DM/24/03487/OUT Land To SW of 27 Durham Road West Bowburn DH6 5AU

Outline application for the erection of up to 20 dwellings and associated open space, SuDs and infrastructure (all matters reserved except access)

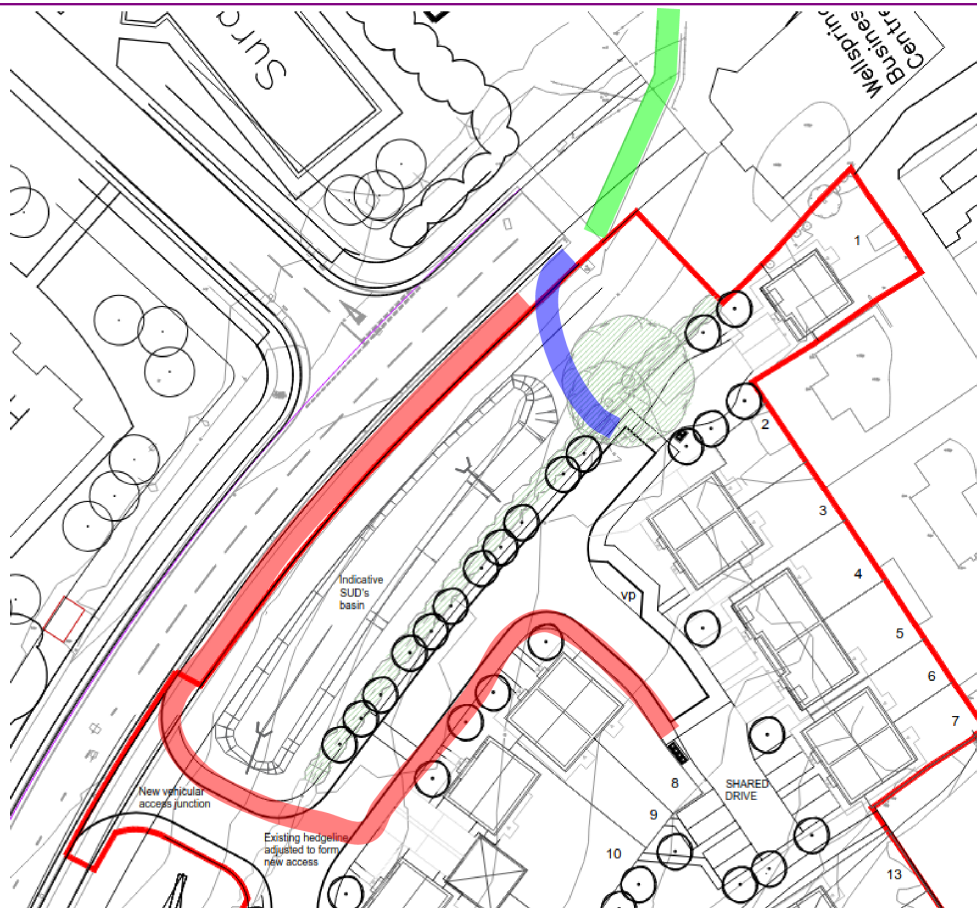
The Trust welcomes the intention to provide direct pedestrian access north-east from the site to the Durham Road. The Planning Statement, para. 5.41 states that the indicative layout:

... includes a pedestrian route to Bowburn from the northeast of the development. The provision of these will be confirmed at the Reserved Matters stage.

Therefore the Trust considers that the planning authority should apply a condition requiring the provision of a pedestrian (and preferably also cycle) link north-east from the site to the Durham Road. While the exact design of the link may be reserved at this stage, the provision of the link should be secured with the approval of the outline application.

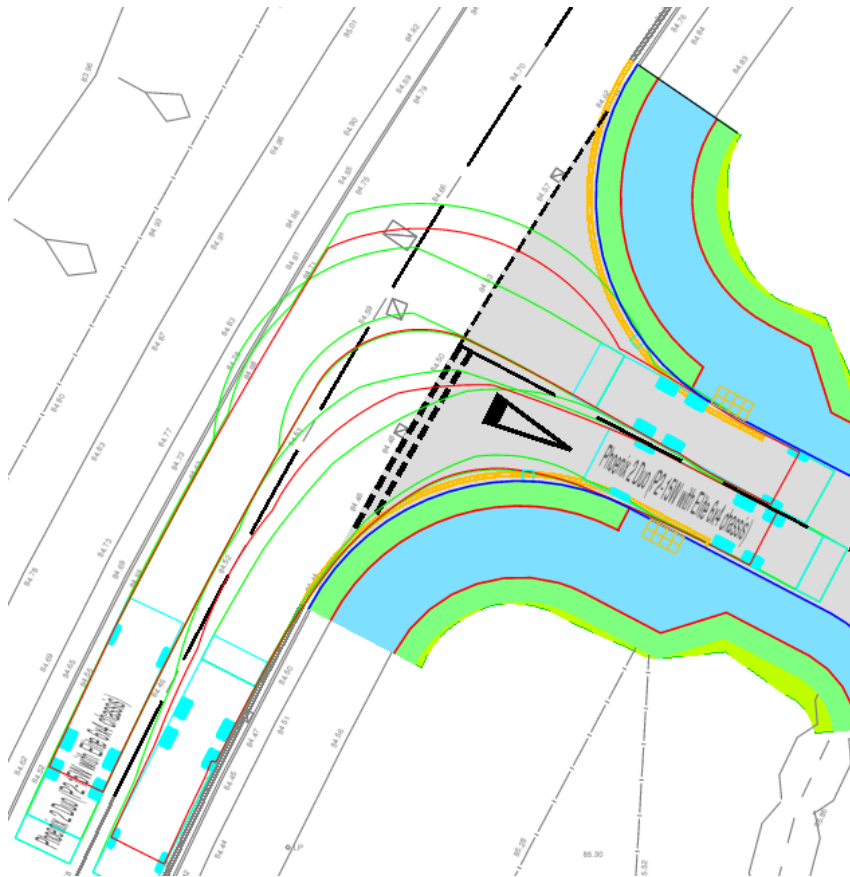
In the following excerpt from the drawings the green route indicates the existing pedestrian link which leads from the end of Rosalind Frankland Way through to Edna Street and Durham Road. The red overlay shows the route that someone would need to walk using the proposed access to the site. This can be substantially shortened if the blue link shown below is also provided. This should be secured at the outline application stage through a condition.

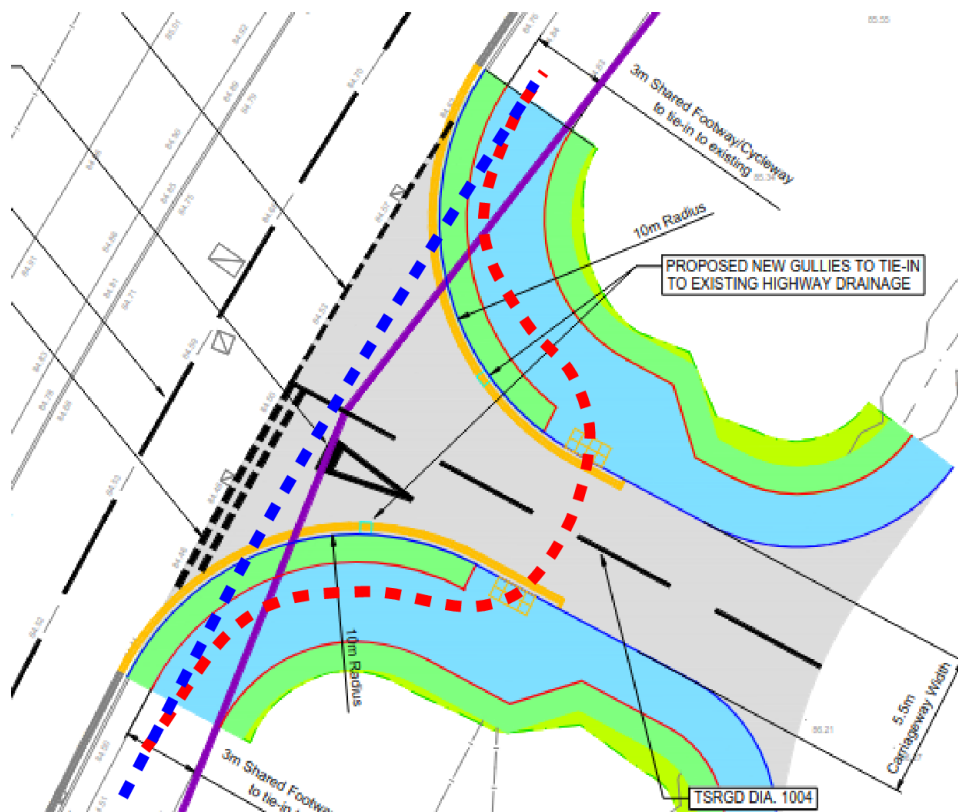
The Trust objects to the design of the access junction proposed on Bowburn Way because it does not prioritise pedestrian and cycle access across the junction. The design disrupts an existing well-designed, direct route for walking and cycling access, and therefore conflicts with Policy 21(b) of the County Plan. The design does not comply with LTN 1/20 or *Manual for Streets* which are national design guidance documents brought into County Durham policy via references in the County Durham Strategic Cycling and Walking Delivery Plan. Policy 21 requires that all development should have regard to the policies of the Delivery Plan and this includes observing the design guidance which is recommended therein.

While the design may comply with the Design Manual for Roads and Bridges (DMRB), this is not the appropriate standard to use for a side road junction serving a development of only 20 properties.

- reducing the radius of the corners, which are shown as 10m;
- providing a continuous and level pedestrian and cycle surface across the junction, to help enforce pedestrian and cycle priority in accordance with Highway Code Rule H2;
- adopting one of the junction designs suggested in LTN 1/20, rather than following DMRB.

The swept path analysis included in the drawings shows that the designers have used corner radii which allow large vehicles like a refuse lorry to enter or leave the development with little or no encroachment on the opposite side of the carriageway.

Large vehicles will only rarely enter a development of 20 houses. It would not cause any difficulty if the refuse lorry had to cross the centre line in order to navigate the junction, as occurs in many older streets. With larger corner radii, cars will be able to take the junction faster, resulting in more danger for any pedestrians or cyclists who are crossing.

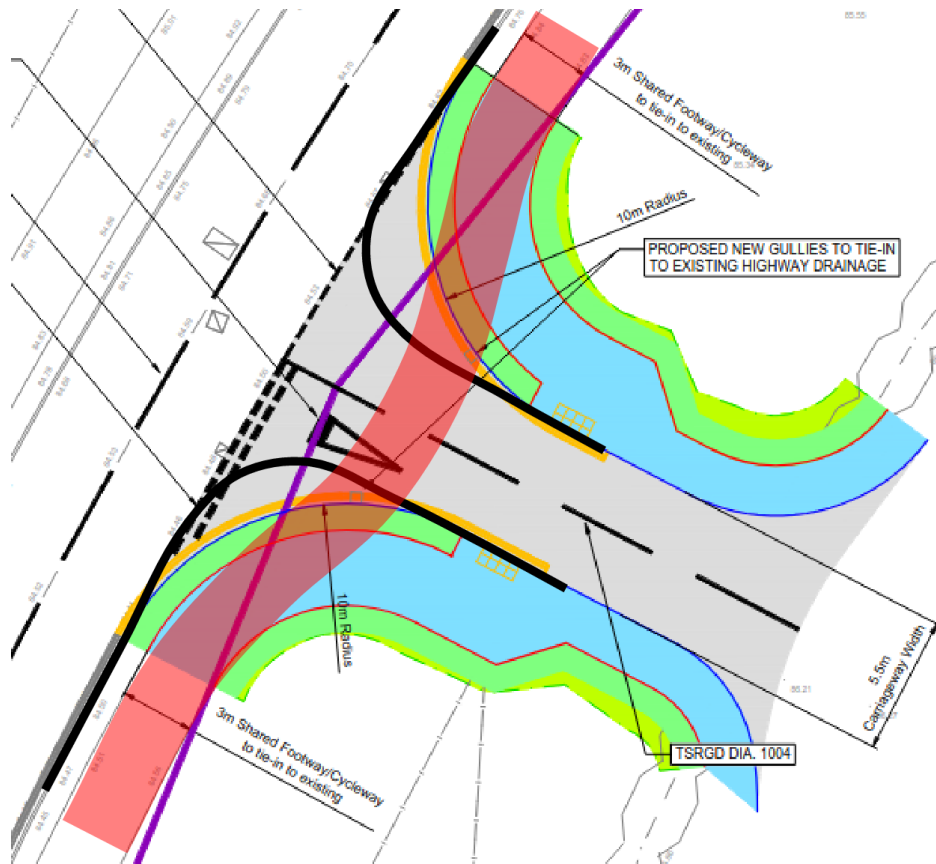
As well as slowing traffic and improving safety, reducing the corner radii will keep the pedestrian and cyclist movements closer to the desire line through the junction. The following drawing excerpt shows the desire line in blue dashes, and the actual route pedestrians and cyclists will have to take as red dashes.

When a pedestrian or cyclists is using a junction like that proposed, as they turn the corner off the main road to access the dropped kerbs, they will have their backs to approaching traffic, which makes it harder to use the junction safely. The tight corners also require cyclists to brake, even if there are no other vehicles around, which increases the energy expended and lengthens the journey time. If this pattern of junction is repeated across an estate, as has unfortunately been the case in the Integra 61 development, this makes the cycle route unattractive to users. It reinforces the impression that the needs of people who are walking and cycling are subservient to those of the motorists.

The following amended drawing shows corners of approximately 4m radius in solid black (but lower would be better). The alignment of the pedestrian and cycle path (shown in red) moves gently away from the carriageway on the approach to the crossing, allowing cyclists to maintain

their speed and minimise muscle effort, and ensuring that pedestrians and cyclists can easily see in all directions for approaching vehicles.

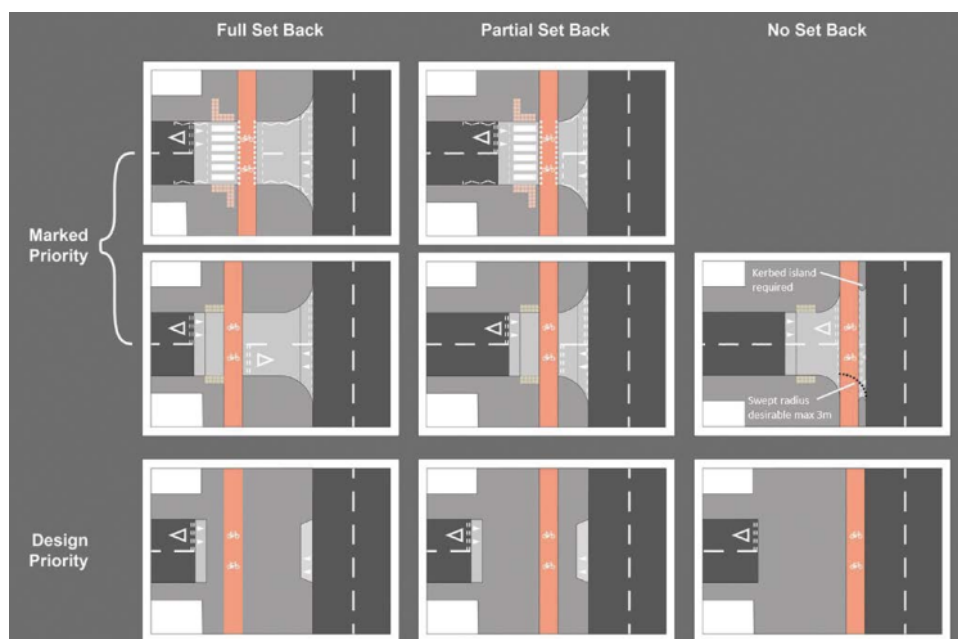
Several designs are possible. The Trust would favour a raised junction table and continuous footway across the junction to give visibility to the priority which should be shown to pedestrians and cyclists in this situation. LTN 1/20 Figure 10.13 depicts various designs for parallel foot and pedestrian crossings with and without a set back from the carriageway. These could easily be adapted to the shared-use environment on Rosalind Franklin Way.
